BID ADDENDUM No. 1

Re: Bond Improvements Phase 2
Briarcliff Manor Union Free School District
SED No. 66-14-02-02-0-004-023 (HSMS)
SED No. 66-14-02-02-0-002-021 (ES)
BBS File No 21-274C, 21-274D

1 LIGHT WELL DEMOLITION SECTION

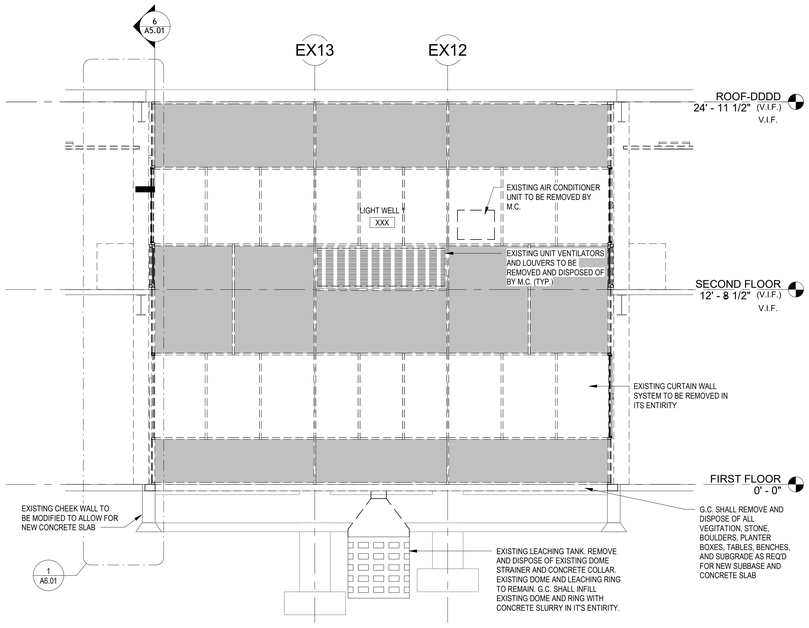
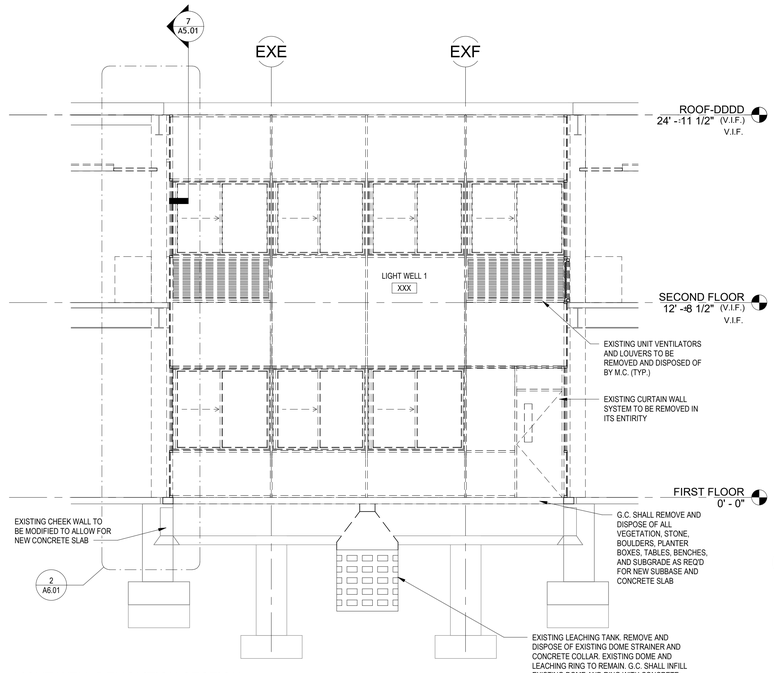
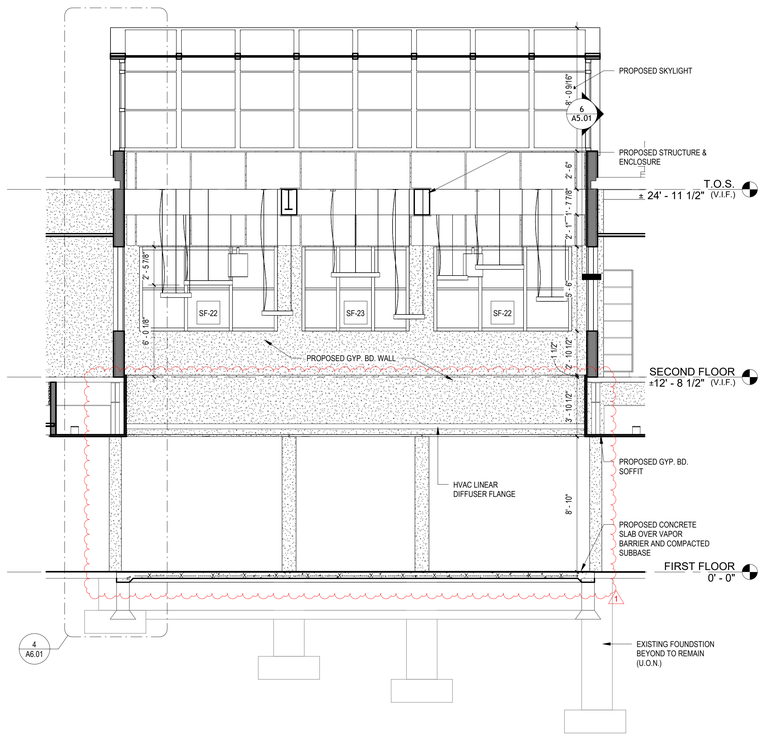
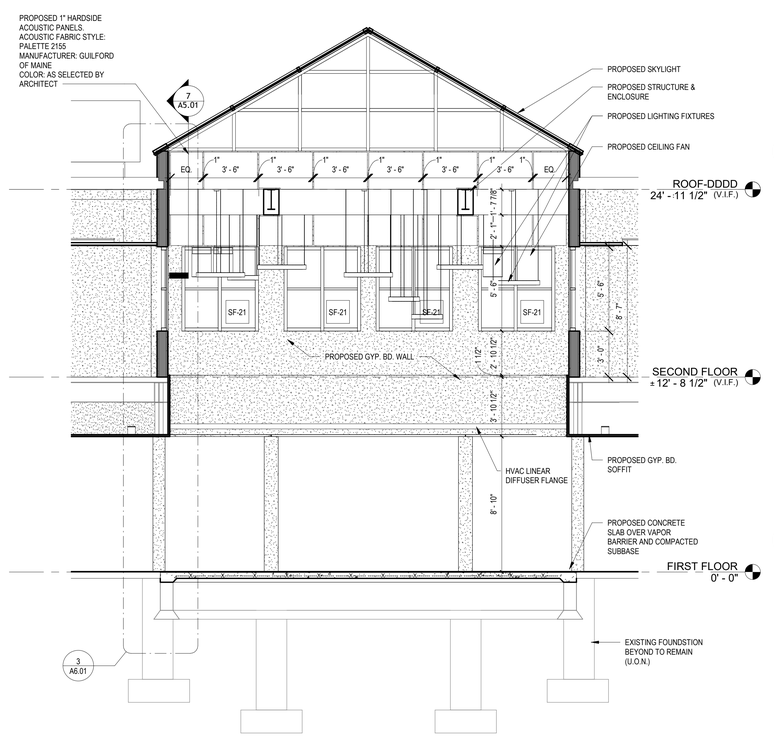
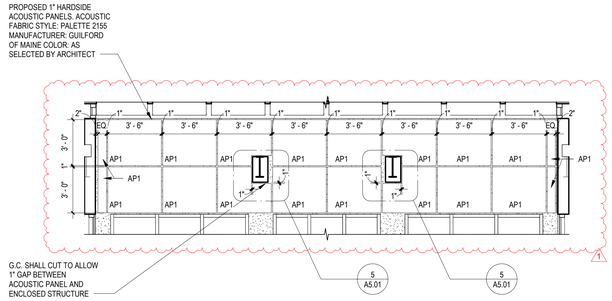
5. **Question:** Acoustical wall panel, no spec, please confirm locations of acoustical wall panels. DWG A9.01 finish schedule shows quiet room only. At all walls floor to new ceiling per A11.04 detail 24? DWG A5.01 section 3 notes acoustical wall panels, what is the extent in light well and dimensions?

BBS Response: Refer to spec section 09500 and revised drawing A5.01included in this addendum.

A9.02 HSMS

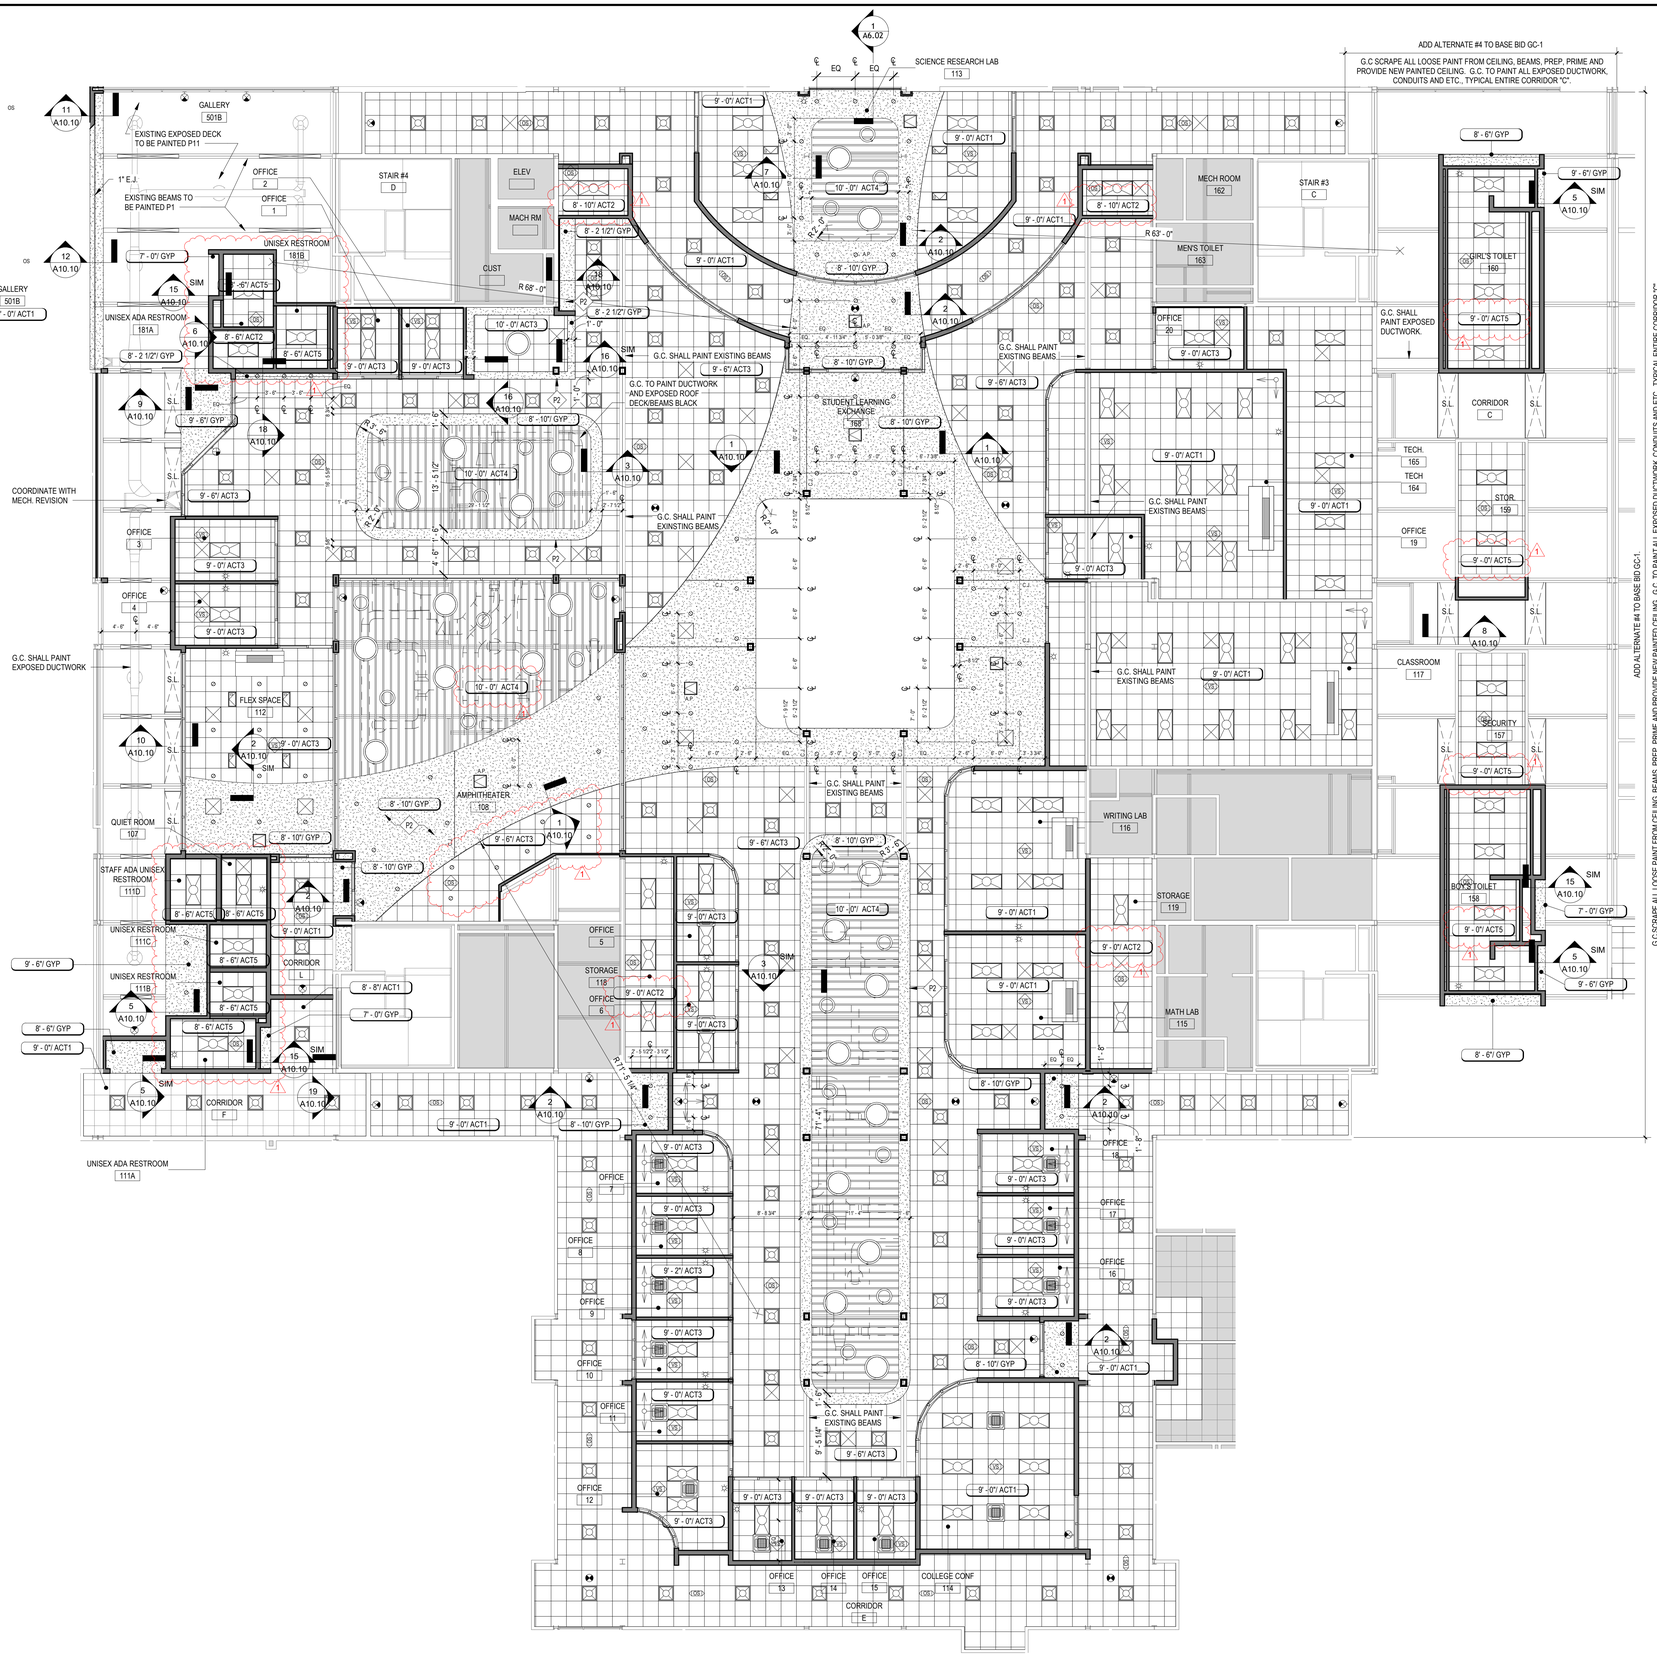
2. **Question:** Drawing A8.01 MSMS door schedule calls out AWD for doors 109B, 166, 167. Please clarify. Drawing A10.02 appears to show ACT 4 as 2'x2' ACT, and ACT as Decoustics. Drawing A9.01 ACT 4 is called out as Decoustics. ACT 5 is called out as 2' by 2' 1935 Ulitma tiles. Pease clarify all ACT for the correct type. Drawing A9.02 shows the same flooring designation in rooms 107, 108, 112, 113, 114,115, 116. Drawing A9.01 on the finish schedule calls LVT in rooms 107, 108, 112, 114 but carpet in room s 114, 115, 116. Please clarify floor types. Drawing A8.01 Calls out door 113B, drawing A2.02 does not show this door number. Please clarify.

BBS Response: Refer to revised finish floor plan and schedules and Drawing A2.02 included in this addendum.
